PUBLIC UTILITIES COMMISSION OF THE STATE OF CALIFORNIA

RESOLUTION SU-10
January 21, 1992

RESOLUTION SU-10, ORDER AUTHORIZING RULE CHANGES
TO GENERAL ORDER NO. 95 (G.O. 95),
RULES FOR OVERHEAD ELECTRIC LINE CONSTRUCTION

Horizontal & Radial Clearances:

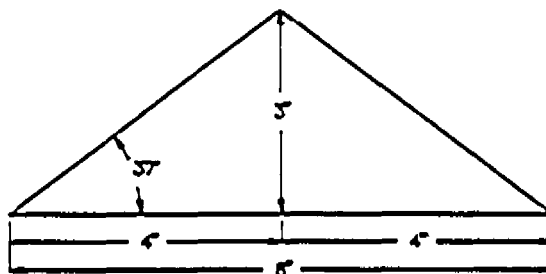
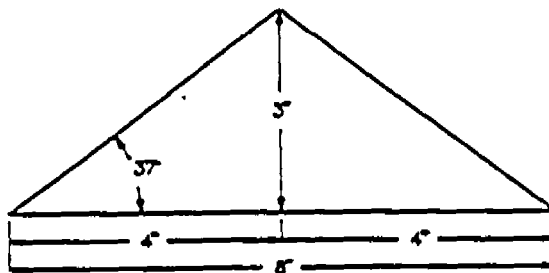
This change simplifies existing language, moves building clearances to Table 10, and puts more emphasis on using Insulated Conductors (particularly when using allowed reduced clearances).

- 1) From fire escapes, exits, windows, and doors. 3' 3'
- (a) No limit specified but the greatest practicable clearance should be obtained.
- (b) The point of attachment of the service drop for industrial and commercial premises is not to be more than 18 inches back of the front face of the building wall facing the pole line from which the service drop originates.
- (c) Reduce to 2 feet for non-metallic roof, more than 3/8 pitch (approximately 37 degrees from the horizontal, see sketch)

- 1) From fire escapes, exits, windows, and doors. 3' 3'
- (a) No limit specified but the greatest practicable clearance should be obtained.
- (b) The point of attachment of the service drop for industrial and commercial premises is not to be more than 18 inches back of the front face of the building wall facing the pole line from which the service drop originates.
- (c) Reduce to 2 feet for non-metallic roof, more than 3/8 pitch (approximately 37 degrees from the horizontal, see sketch)

F. CLIMBING SPACE IN EXTENDED RACK CONSTRUCTION

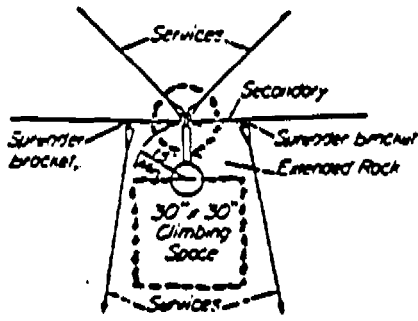
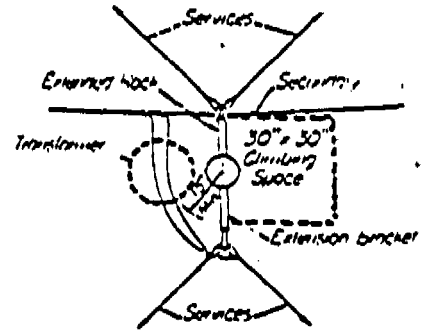
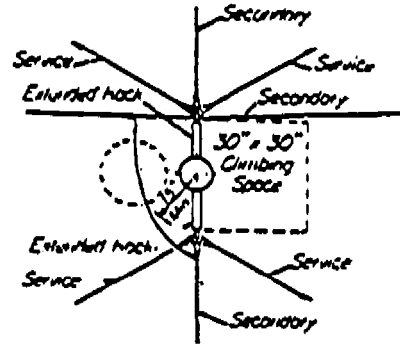
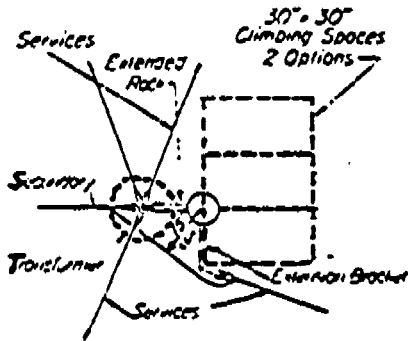
Deviations from General Order 95 which permit the use of extended rack construction were granted in Resolution No. E-1013 on February 9, 1959 and revised by Decision 82-03-020 in 1982. These deviations were granted solely to Pacific Gas and Electric Company. It is proposed to make this type of construction available to all utilities in the State of California. A new Rule 54.12 titled "Low Voltage Extended Racks, 0-750 Volts" will be added to General Order 95, Section V. Also, a new drawing Fig. 54-9 showing climbing space will be added.

The climbing space in extended rack construction shall be maintained through the level of conductors supported in extended rack construction and for a vertical distance of not less than 4 feet above and below such conductors. The position of the climbing space through the level of conductors in extended rack construction shall be related to climbing space for conductor levels above and below such extended rack construction in accordance with Rules 54.7, 54.10, 54.11 and 93. The depth of the climbing space shall be measured from the center line of the pole.

(3) **Allowable Climbing Space Obstructions:** Suitably protected vertical runs or risers and ground wires attached to the surface of the poles, and guys, are allowed in climbing spaces provided that no more than two guys (provided they are separated at the pole by a vertical distance of not more than 18 inches) or one vertical riser, run, or ground wire is installed in any 4-foot vertical section of climbing space. The terminals or terminal fittings of risers or runs shall not be installed within climbing spaces.

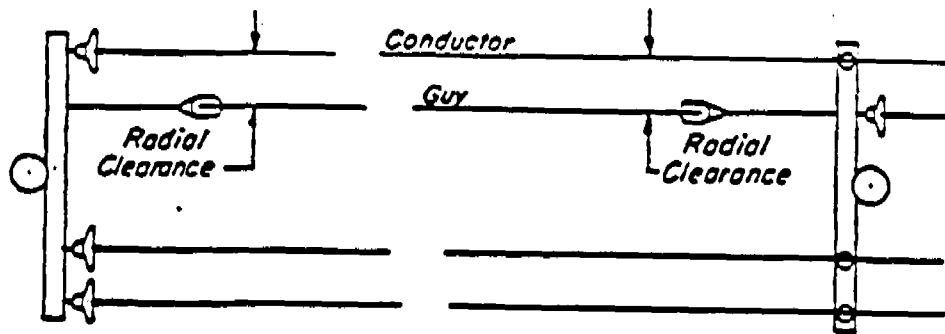
The proposed rule change is to simplify and clarify the present language. Also, add a new drawing (Fig. 56-1) opposite the text for illustration of Rule 56.4-C3.

(3) Parallel on Same Poles: The radial clearances between guys and conductors which are approximately parallel and supported by the same poles shall ~~be~~ not be less than as specified in Table 2, Case 18. (see Fig. 56-1).

(3) Parallel on Same Poles: The radial clearances between guys and conductors which are approximately parallel and supported by the same poles shall not be less than as specified in Table 2, Case 18. (see Fig. 56-1)

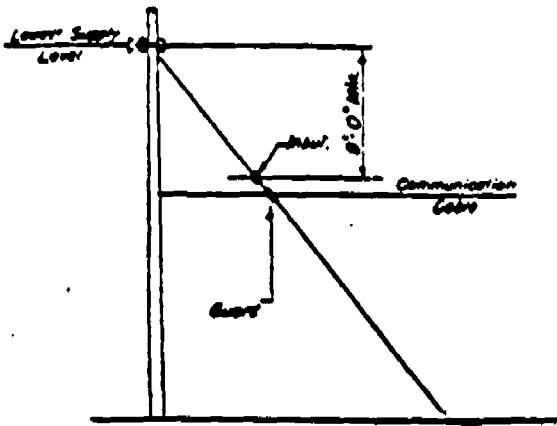
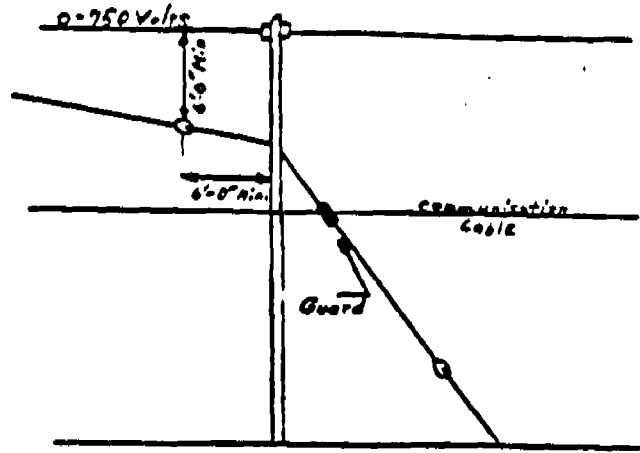
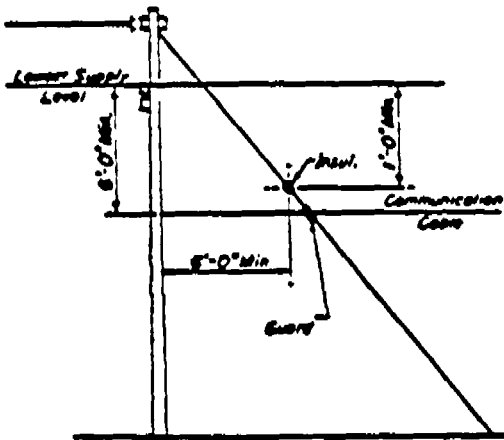
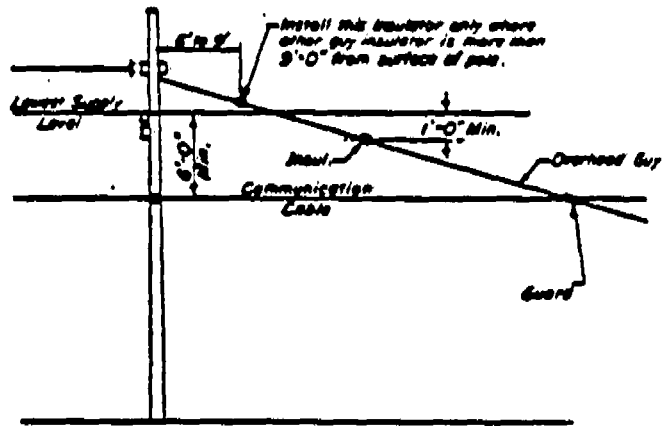
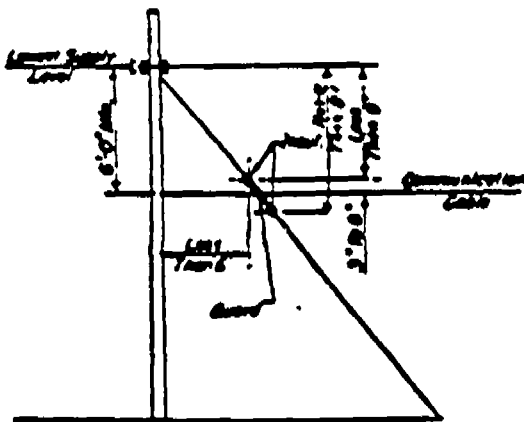
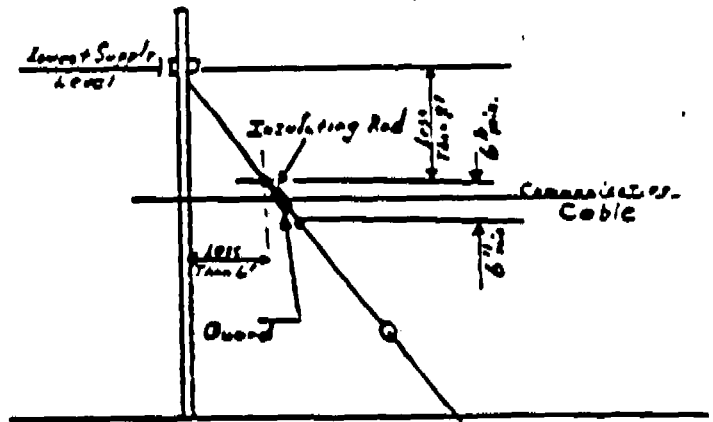
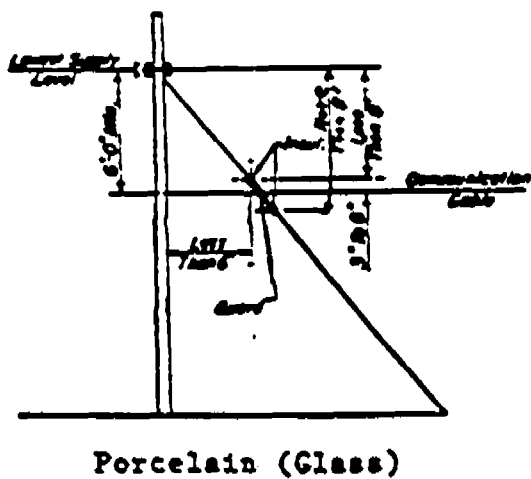
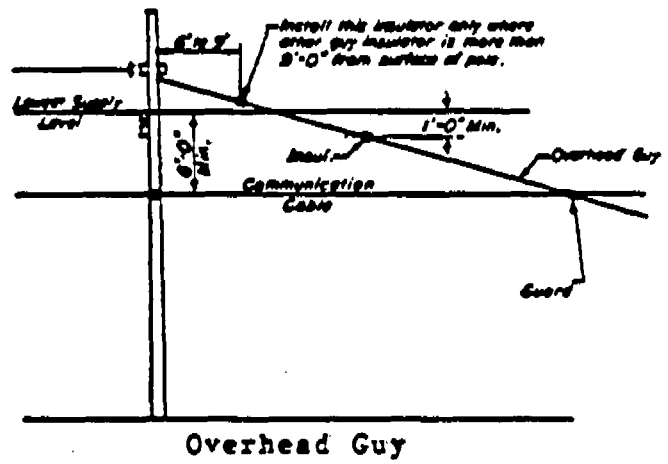
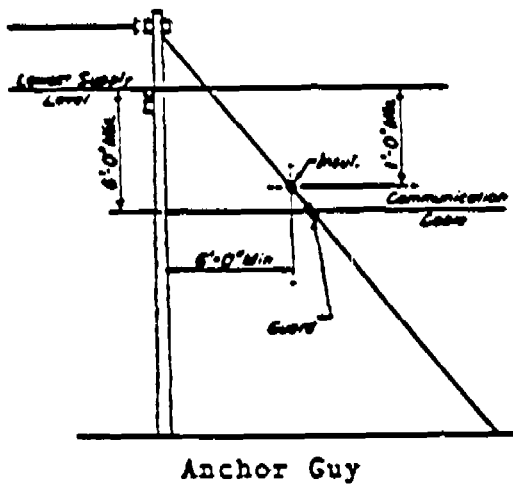
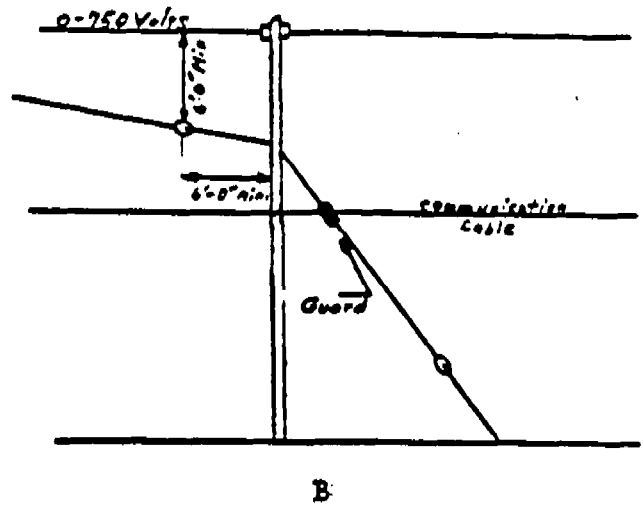
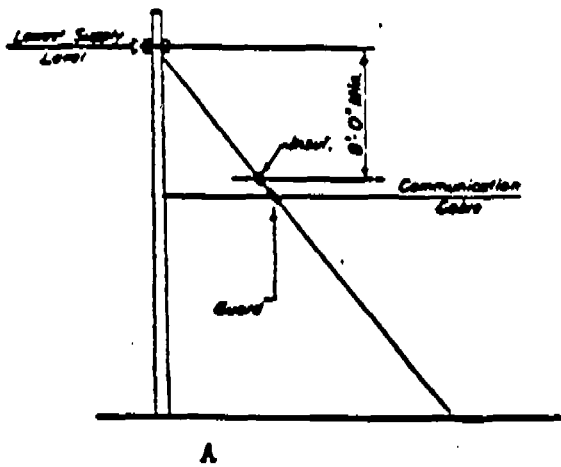
The proposed rule change is to simplify and clarify the present language. Changes include re-structuring, re-formatting and minor changes in syntax. Also, a drawing is being added opposite the text for reference and ease of application (Fig. 56-2). The requirement for a suitable guard in the exceptions has been broadened to be included in all of the applications.

In lieu of a porcelain insulator a suitable fiberglass insulating rod or equivalent that meets the requirements of Rule 56.8 and extends 6 inches or more above and below the communication messenger and/or cable may be used.
(see Fig. 56-2 D).

- (b) The guy is not a guy in proximity; or
- (c) An insulator is placed in the guy above the communication messenger and/or cable at a vertical distance of not less than 8 feet below the supply conductor level, (see Fig. 56-2 A); or

Fig. 56-3

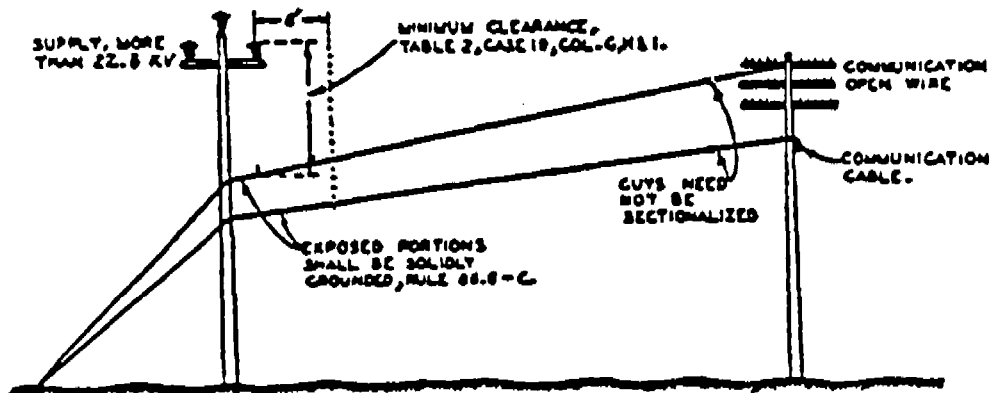
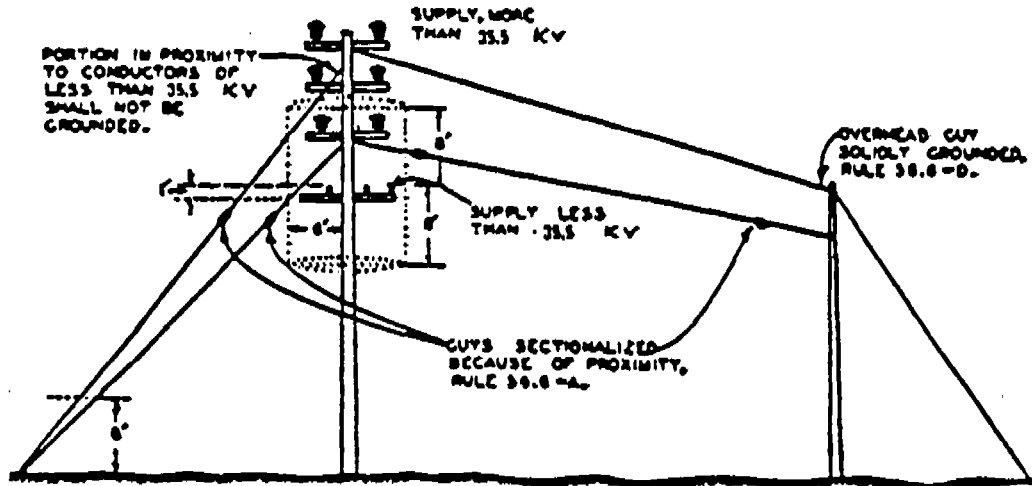
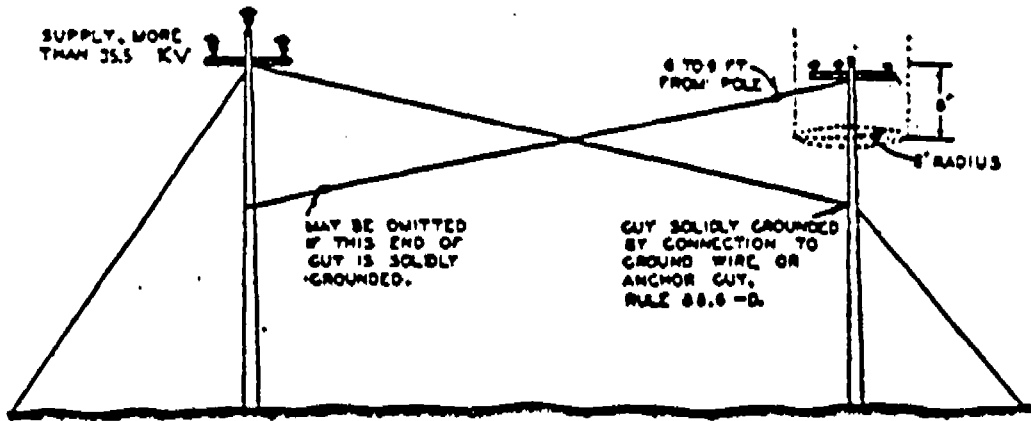
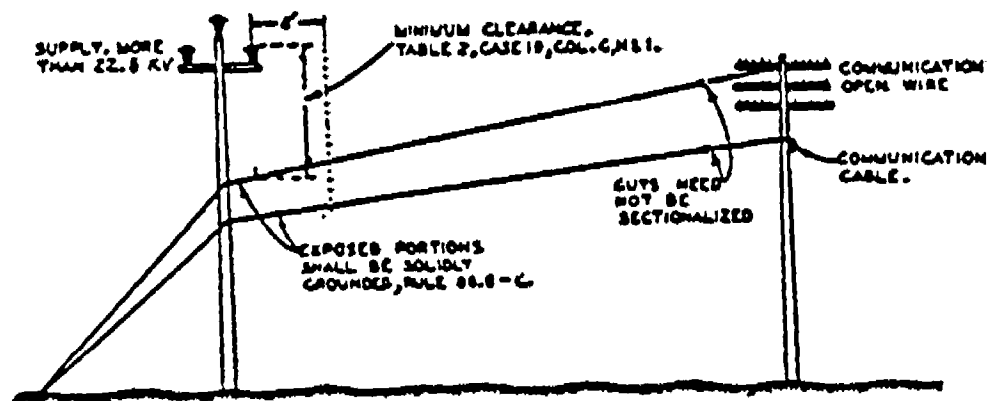
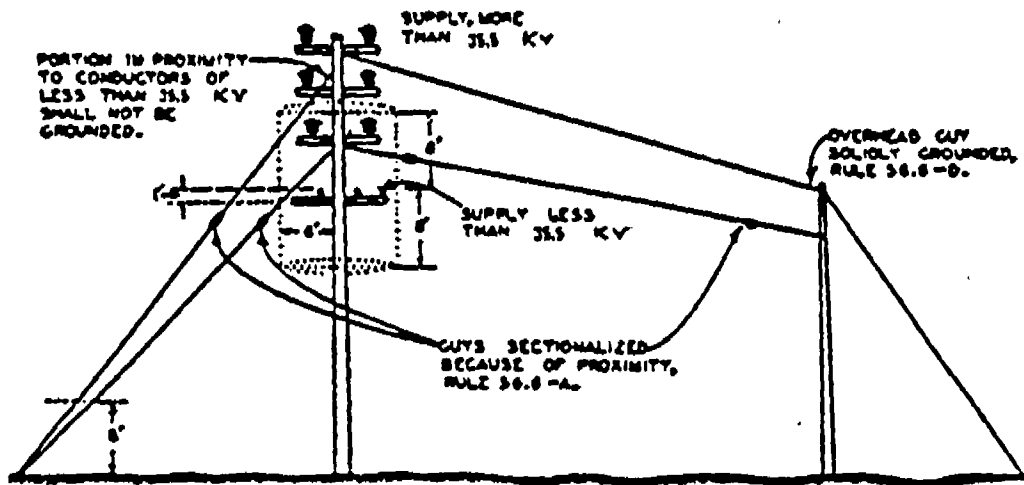
This proposed rule change simplifies the rules format. Also, it is proposed to add related figures from Appendix G to the text opposite the rule numbers and change to current numbering sequence (Fig. 56-3 and Fig. 56-4).

Fig. 56-5

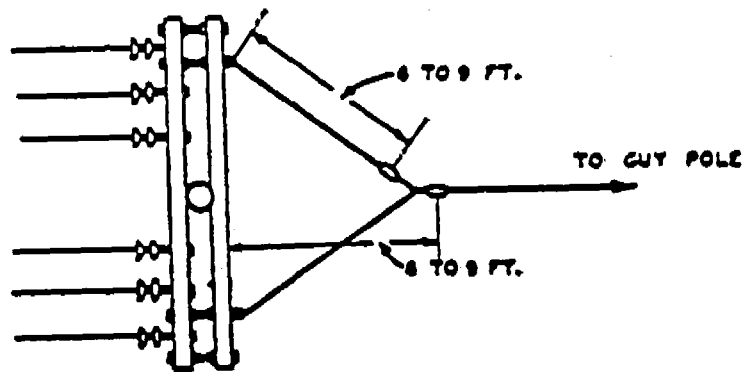
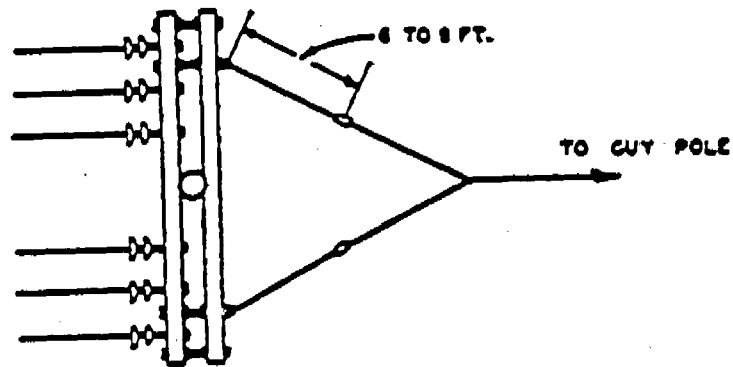
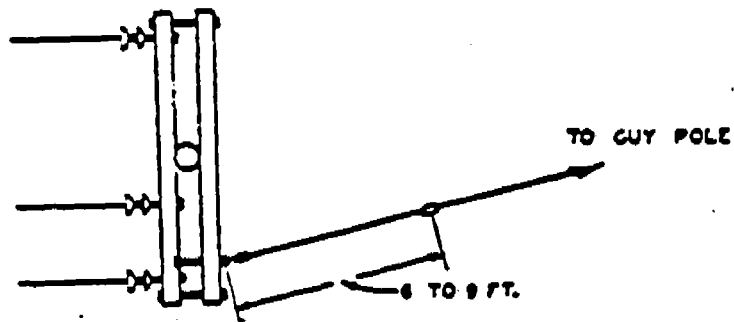
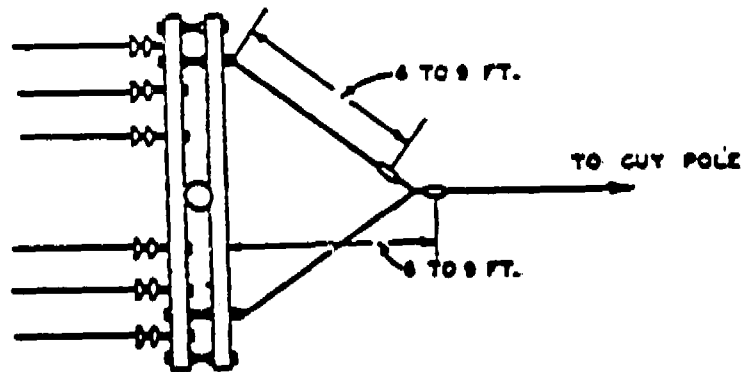
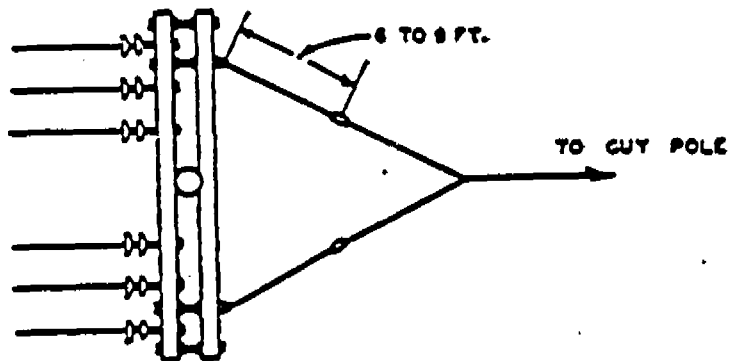
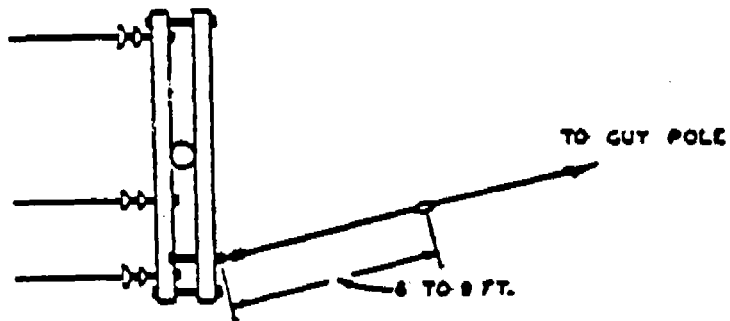
The proposed rule change is to simplify and clarify the present language. Also, relocate related figures from Appendix G to the text opposite the rule number and change to current numbering sequence (Fig. 56-5, Fig. 56-6 and Fig. 56-7).

Insulators installed in overhead guys to sectionalize such guys as required by any portion of Rule 56.6 shall be located at a distance of not less than 6 feet and not more than 9 feet, measured along the guys, from the points of attachment of the guys to poles, crossarms or structures (see App-67-Fig-46 Fig. 56-5 and Fig. 56-6).

Insulators installed in overhead guys to sectionalize such guys as required by any portion of Rule 56.6 shall be located at a distance of not less than 6 feet and not more than 9 feet, measured along the guys, from the points of attachment of the guys to poles, crossarms or structures (see Fig. 56-5 and Fig. 56-6).

Overhead guys attached to wood poles, crossarms or structures and to grounded anchor guys or metal poles shall be sectionalized at not less than one location, 6 to 9 feet (measured along the guys) from the attachment at the wood pole, crossarm or structure (see Fig. 56-5 and Fig. 56-6).

Fig. 56-8

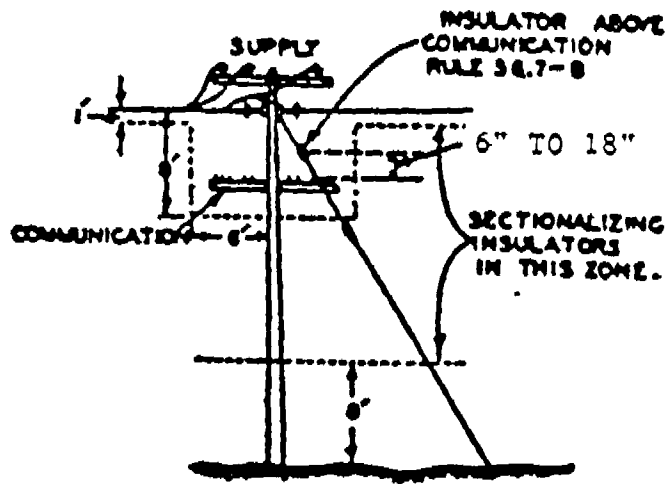
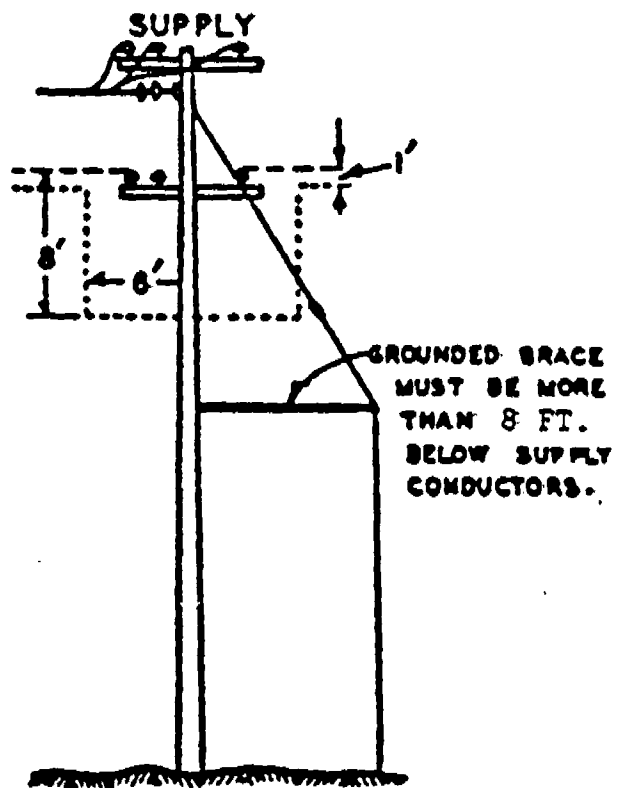
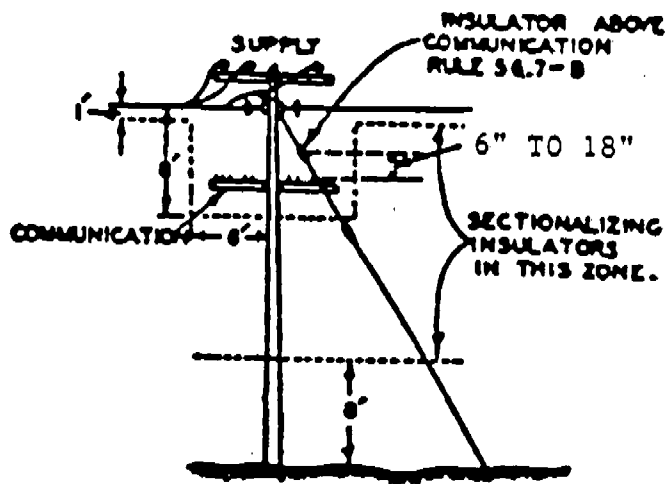
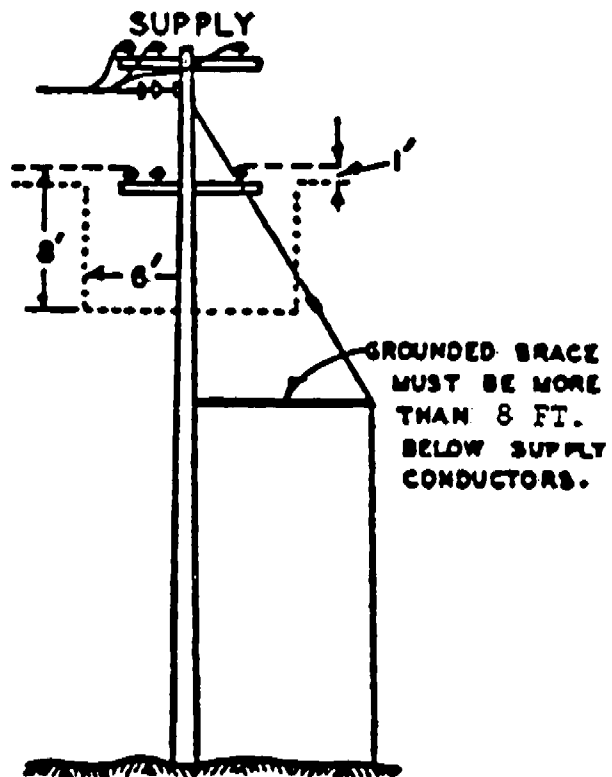
This proposed rule change simplifies and clarifies the present language. Changes include re-structuring, re-formatting and minor changes in syntax. Also, it is proposed to add related figures from Appendix G to the text opposite the rule number and change to current numbering sequence (Fig. 56-8 and Fig. 56-9). At this time it will also be necessary to leave the current App. G, Fig. 49 and Fig. 51 in the appendix because other rules in the order refer to these figures.

- (a) One location being 8 feet or more above the ground; and
- (b) The other location either 8 feet or more below the lowest supply conductor; or 6 feet or more horizontally from surface of pole and one foot or more below the level of the lowest supply conductor.
